Service Manual

Introduction of CDR880

For CDR880 we refer to the service manual of CDR870 service code number 4822 725 25241 except the following differences:

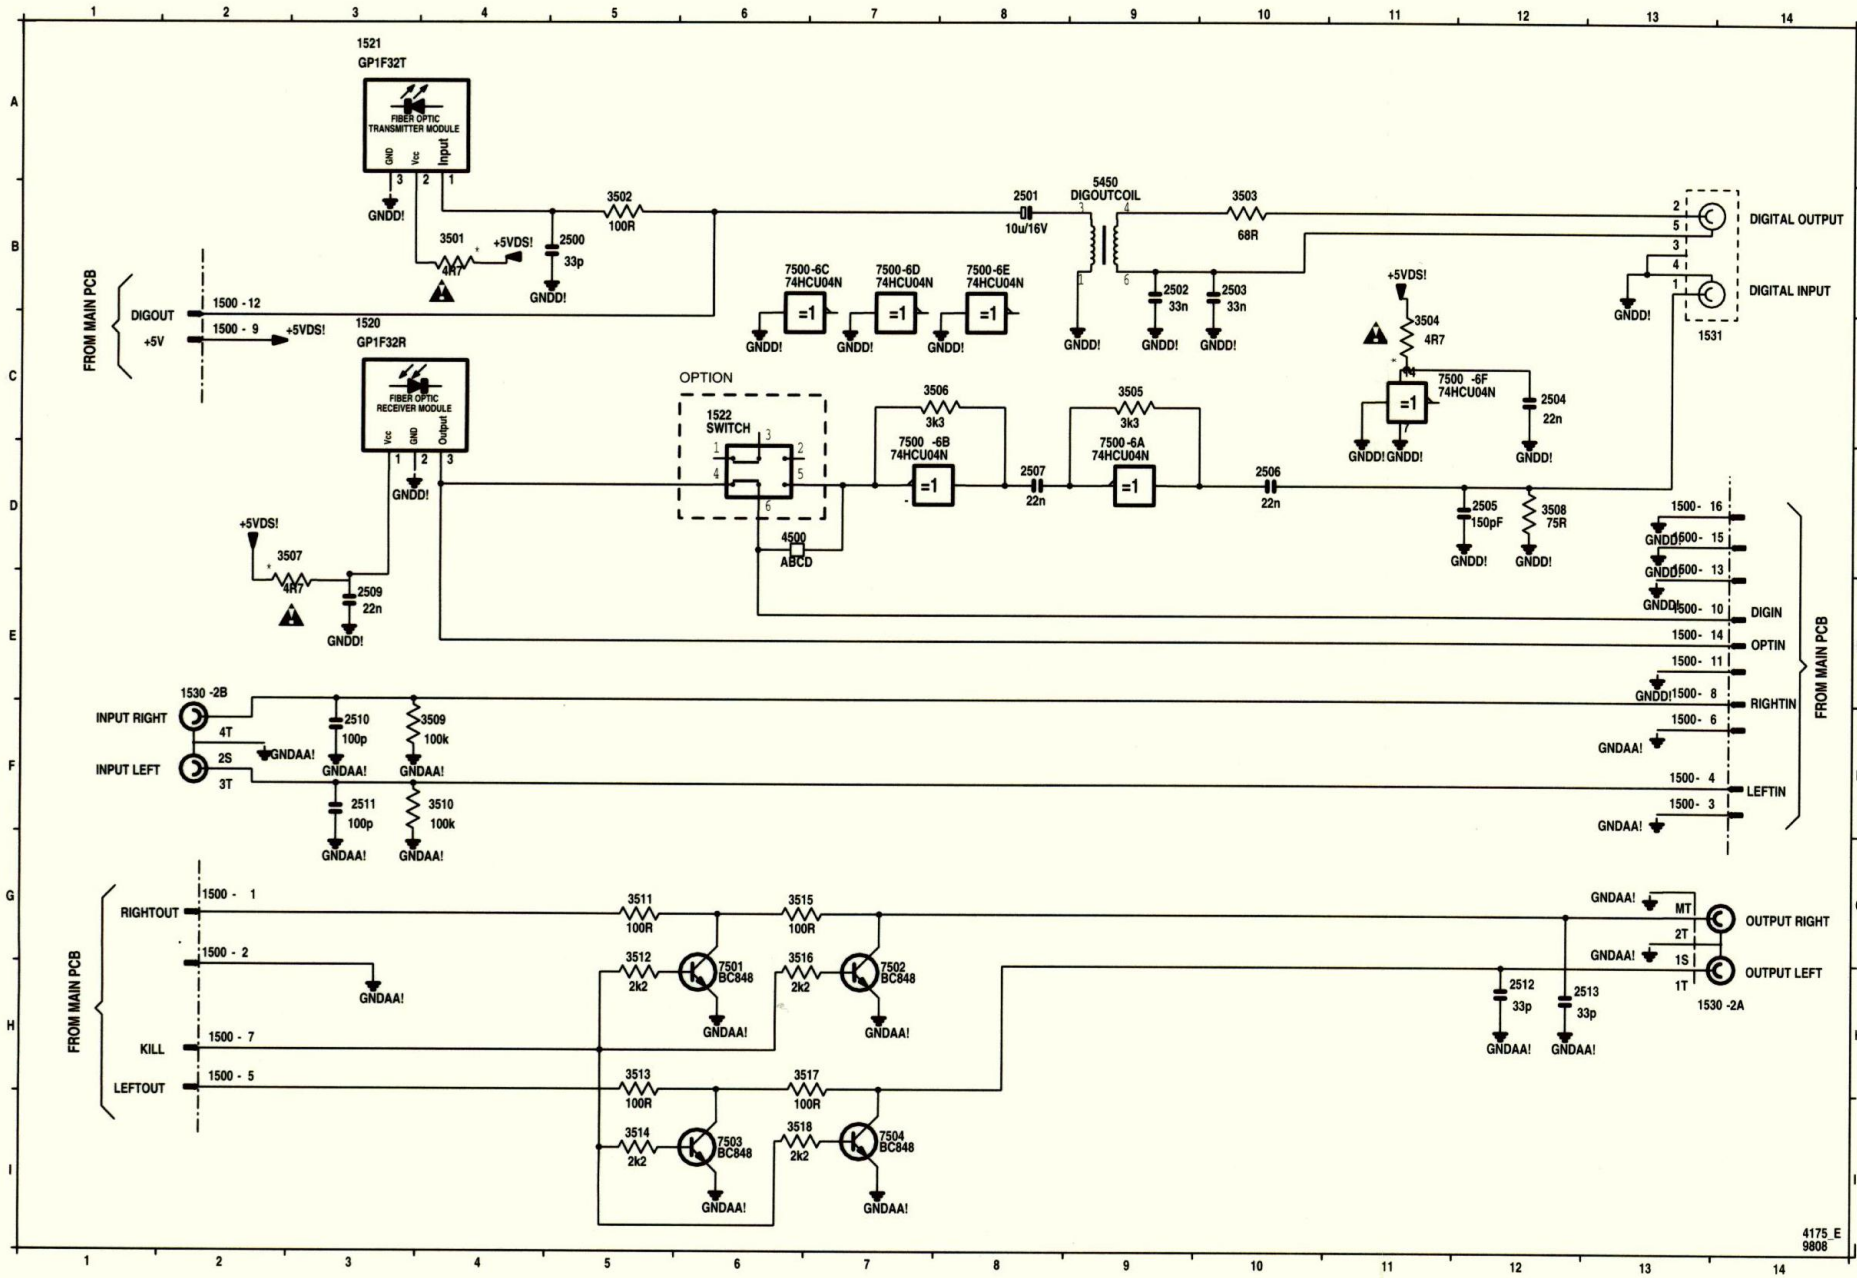
A modified connector board to improve recordings via optical input has been implemented in CDR880. The optical devices have been changed into a new type.

Optical receiver position 1520: GP1F32R. Service code number: 4822 218 11987.

Optical transmitter position 1521: GP1F32T. Service code number: 4822 130 10845.

See added circuit diagram and PCB drawing.
